Re: Vulture Mine Heap Leach  
15 Miles South of Wickenburg, Arizona

SHB Job No. E89-217  
Letter No. 1

Re: Consulting Services  
Heap Leach Facility  
Vulture Mine Project  
Approximately 7 Miles South  
of Wickenburg, Arizona

This letter is submitted on behalf of A.F. Budge (Mining) Limited (Budge) in response to the notification of violations of Groundwater Quality Protection Permit G-0090-07 at the above referenced project. The letter of notification, dated September 26, 1989, was prepared by Mr. Michael A. Milczarek, Groundwater Permit Writer for the Arizona Department of Environmental Quality (DEQ), and included a September 15, 1989 site visit report (dated September 25, 1989) and a DEQ internal memorandum (dated September 26, 1989). Subsequent sections of this letter present our understanding of the conditions at the project facility and our responses to the DEQ requests.

**FIGURE 1**  
**PLAN VIEW OF HEAP LEACH FACILITY**

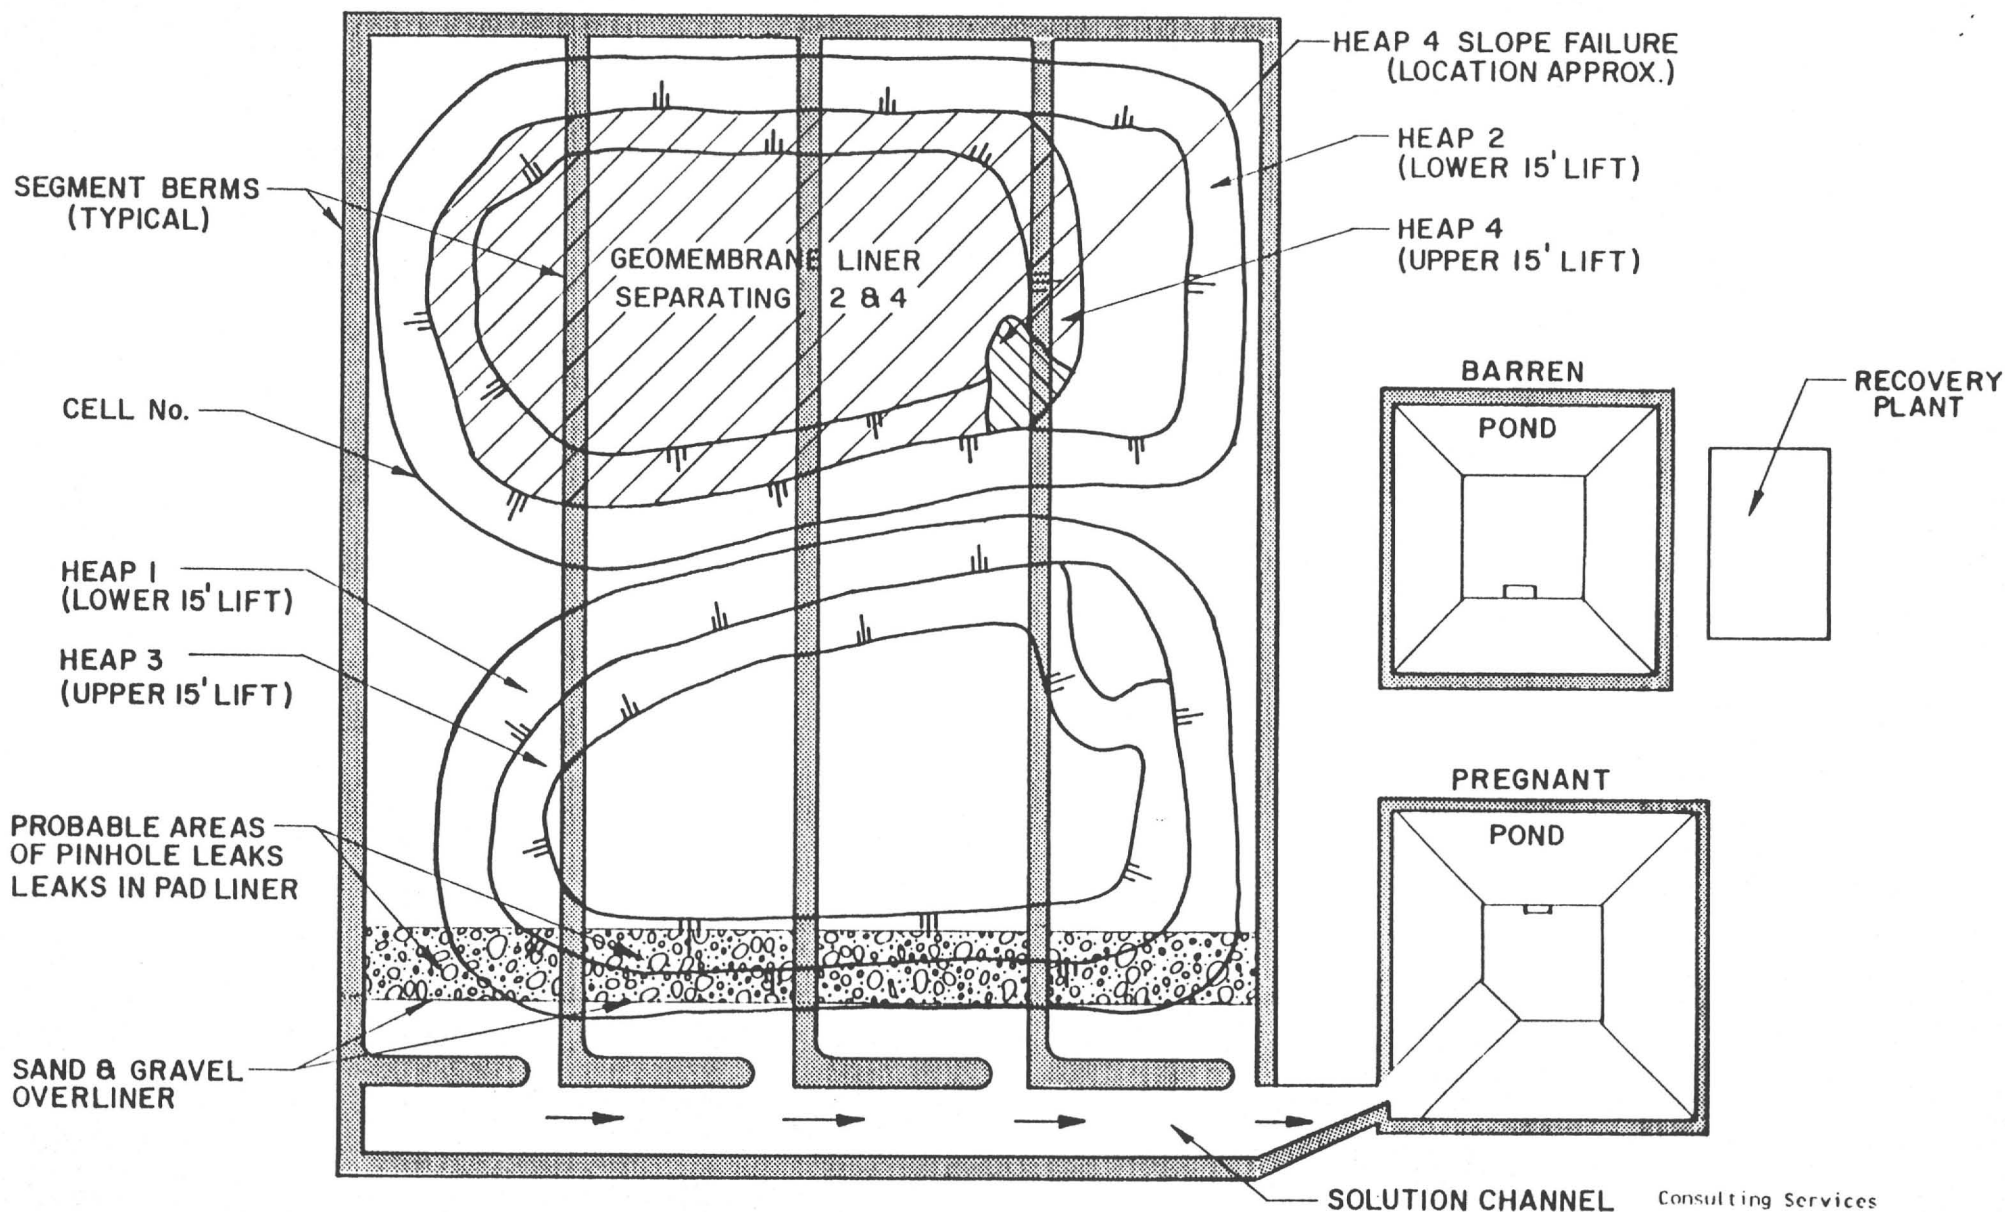
Leach solution was originally detected in the cell no. 2 leak detection system riser pipe, located at the southeast corner of the pad cell, on August 7, 1989. The attached Figure 1 presents a plan view of the heap leach facility. The leakage rate was initially estimated at about 0.0013 gallons per minute (gpm), and tests on the fluid performed by Budge personnel indicated a pH of 11.1 and a free cyanide concentration of 250 milligrams per liter (mg/l). In accordance with the requirements of Parts II.A.4, II.B.1.b and II.C.1 of Groundwater Quality Protection Permit No. G-0090-07, this initial leak was reported to the DEQ and the Maricopa County Health Department in our letter of August 10, 1989.

Application of leach solution to the south half of cell nos. 1, 2 and 3 (the heap no. 3 area as presented in Figure 1) was discontinued on September 22, 1989. As can be seen in Table 1, as of October 17, 1989, the leakage flow rate had generally decreased from an upper limit of 0.04 gpm to 0.01 gpm, with minor fluctuations in mid-September, 1989. The free cyanide concentration and pH also decreased from highs of 300 mg/l and 11.7 to 50 mg/l and 8.3, respectively.

The existing leach pile height is about 30 feet, comprised of two 15-foot lifts. The individual 15-foot lifts are numbered as shown in Figure 1. The separation between the north and south heaps as shown in Figure 1 was purposely maintained during stacking of the tailings on the leach pad in order to provide some independence between the north and south halves. Four to six corrugated, perforated drainage pipes per cell are located on the pad liner, immediately beneath heaps 1 and 2. These pipes function to keep the solution head in the heaps at a low level by augmenting the drainage of the heaped tailings.

As depicted in Figure 1, a 20-mil thickness HDPE geomembrane liner panel was placed on the crest of heap no. 2, prior to stacking the heap no. 4 lift. This liner panel was placed by Budge personnel in an attempt to confine the leach solution to the upper (heap no. 4) lift, preventing releaching of the spent heap no. 2 tailings. It is our understanding that during leaching of heap no. 4, a leach solution line located at the southeast corner of the crest of heap no. 4 failed, resulting in inundation of that portion of the heap. Aided by the low basal frictional resistance caused by the underlying geomembrane liner, the saturated tailings slope then failed.

It is our opinion that the slopes of the heaps as presently configured are in a stable condition, except as noted below. During stacking of the tailings, the slopes assumed angles of repose particular to the materials involved. As discussed previously, the existing slopes are in the range of 1.15:1 to 1.73:1, yielding angles of repose of about 30 to 41 degrees. This range in slope angles is both typical and reasonable for the heaped tailings. It is felt that, for the 30-foot pile height involved, a seismic setback between lifts is not necessary. Because of the underlying liner panel, it is anticipated that localized failures of the heap no. 4 slope may occur in areas that become overly wetted by leach solution; however, it is expected that such failures will be of insufficient extent to restrict the solution channel or extend over the perimeter berm.
